## Video Products Technical Bulletin 30-2009-041

SUBJECT: DAMAGE TO VIDEO OUTPUT IC

MODEL: PVM-14L5  
PVM-20L5  
PVM-D14L5  
PVM-D20L5

**Figure 2**

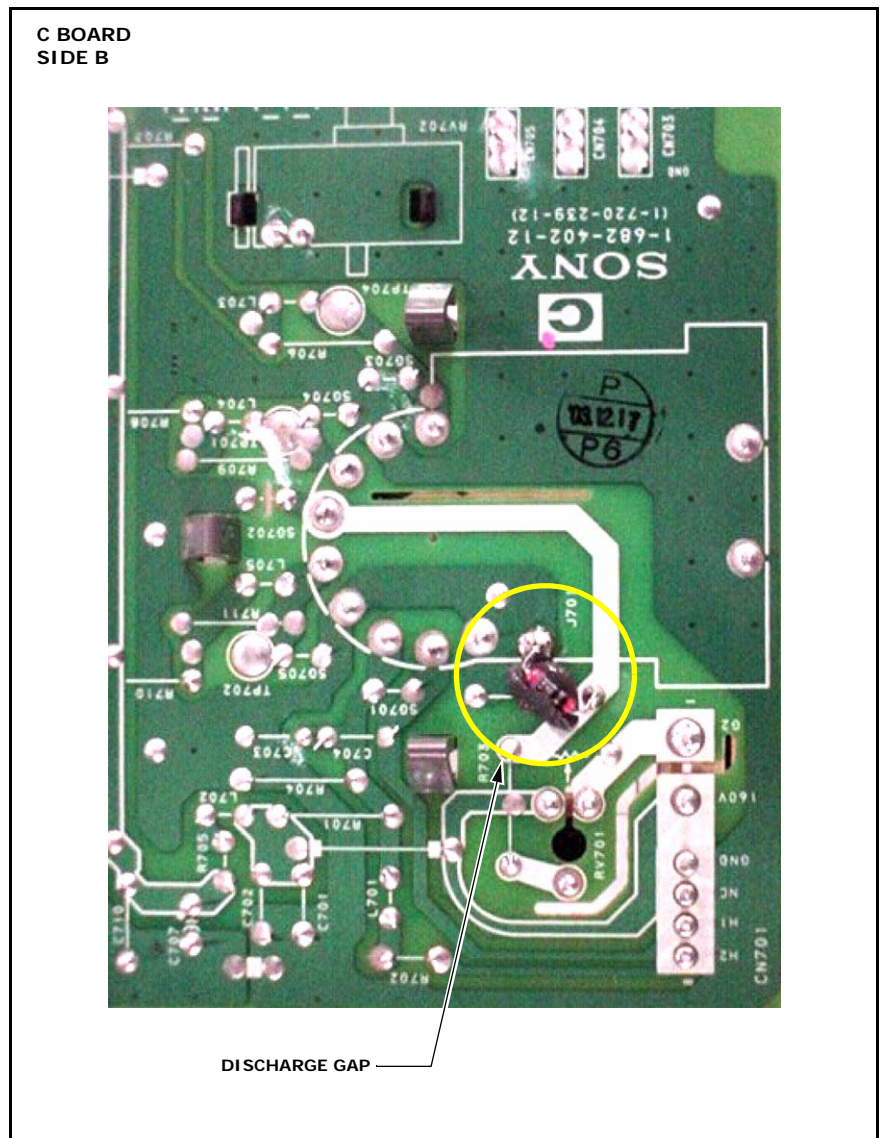
4. Solder a discharge gap between G2 and GND. If a discharge gap is already installed, replace it with a new one. (See Figure 2.)

**NOTE:** Maintain a clearance of 1 mm or more between the discharge gap and the board, and avoid contact with the board. Maintain a height of 7 mm or less from the board.

5. Secure the discharge gap to the board with RTV.
